ENGINEERING INSTRUCTION

NEW YORK STATE DEPARTMENT OF TRANSPORTATION

SUBJECT: SPOT WELDING GUIDE RAILING POSTS

ALTERNATE FABRICATION DETAILS FOR GUIDE RAIL POSTS

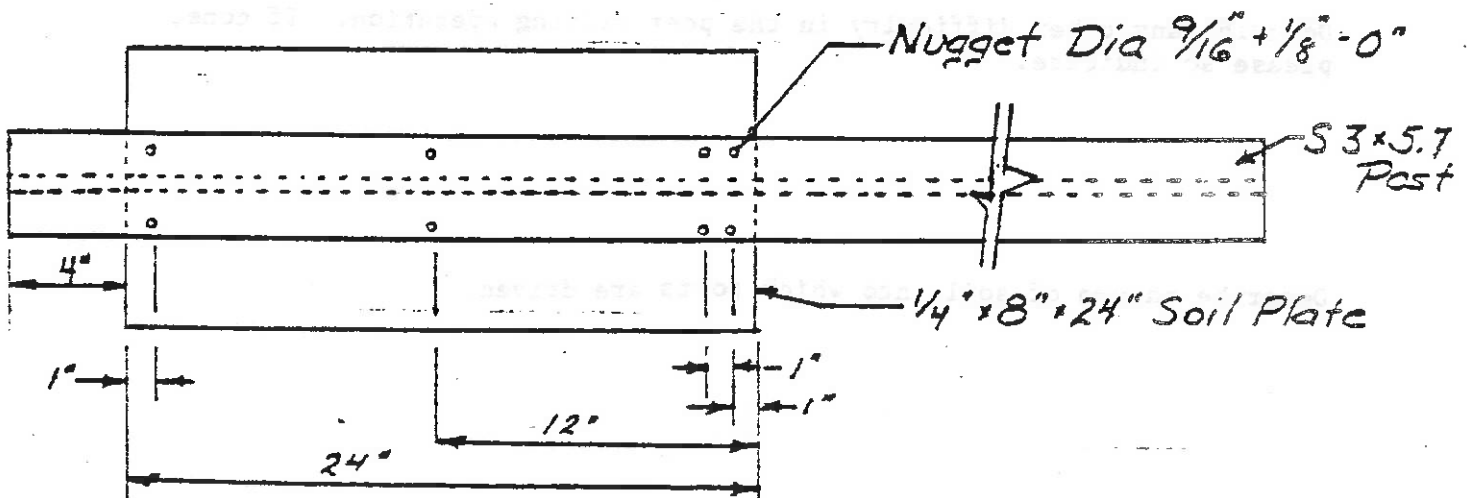
A New York fabricator/erector of guide railing has proposed an alternate method of attaching the 8"x24" soil resistance plate to the post. The method uses a spot welding procedure in place of the fillet welds indicated in the present standards. Some limited testing has been performed to determine the suitability of the spot welds for posts. Based on these tests it appears that posts with spot welded plates can be driven successfully; therefore, we intend to permit this alternate on a trial basis in contracts to be completed in calendar 1983. It is not to be permitted for median barrier posts, because these posts may be struck from either side.

Spot welding of guide rail posts is hereby offered as an alternate fabrication procedure on a trial basis in order to assess satisfactory field installation performance as determined by the Department

This spot welding detail may be used as an alternate for the 8"X24" plate to post welds shown on the Department's Standard Sheets for guide rail.

The Contractor is advised that the spot welded posts are to provide equal performance as the conventionally welded posts during installation. Should they fail to do so, they shall be replaced by the Contractor at no cost to the State.

The minimum number, size and location of the welds shall be as indicated below:
